# *FINAL ENVIRONMENTAL IMPACT REPORT*

## *Green Hollow Square*

*Case No. ENV-2009-1065-EIR*

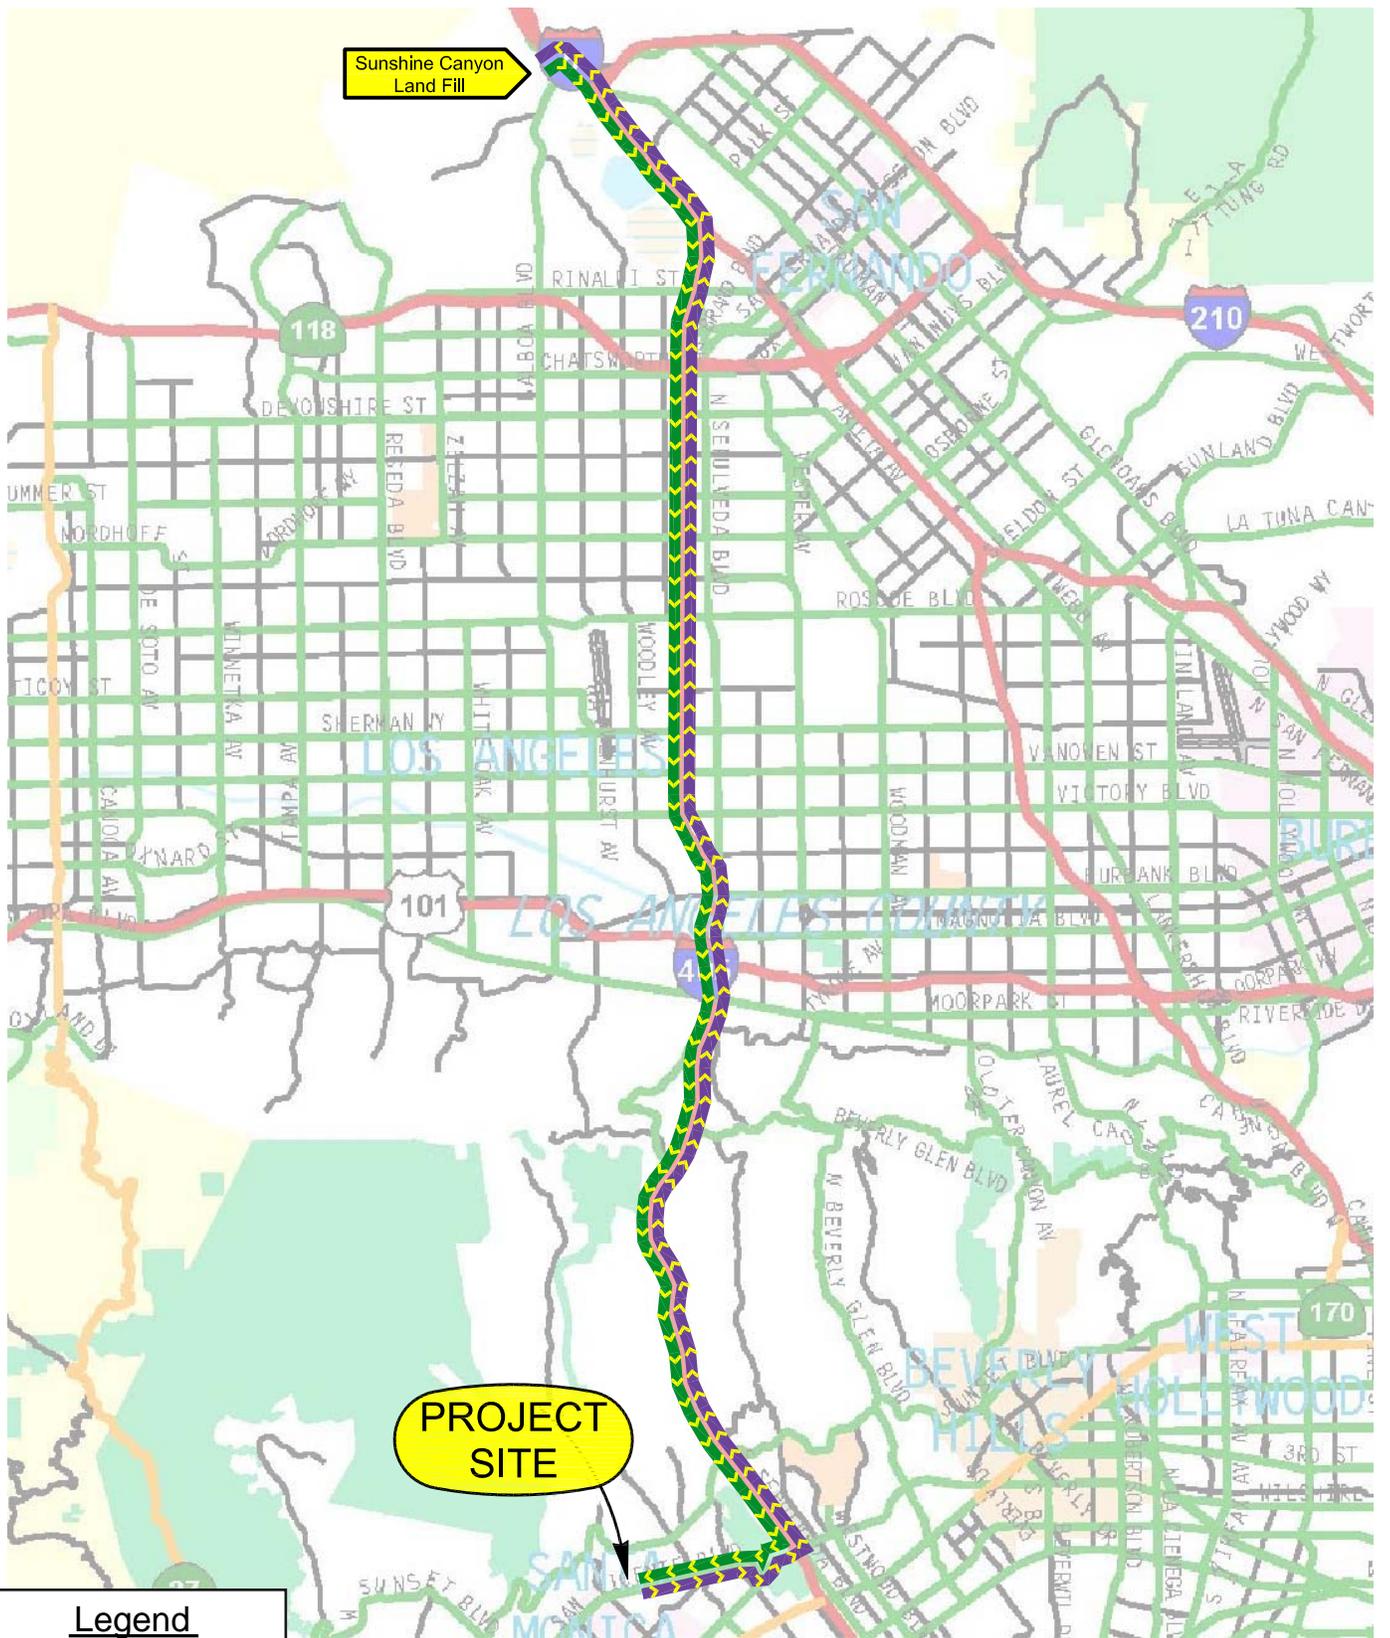
The destination location for most of the material removed from the project site is anticipated to be the Sunshine Canyon Landfill at 14747 San Fernando Road, on the west side of the I-5 (Golden State) Freeway, between the I-210 (Foothill) Freeway and the CA-14 (Antelope Valley) Freeway, in the Sylmar community of the City of Los Angeles. It is expected that the haul vehicles would travel between the local project area and the landfill via the I-405 (San Diego) and I-5 Freeways, as shown in new Figure IV.L-16A.
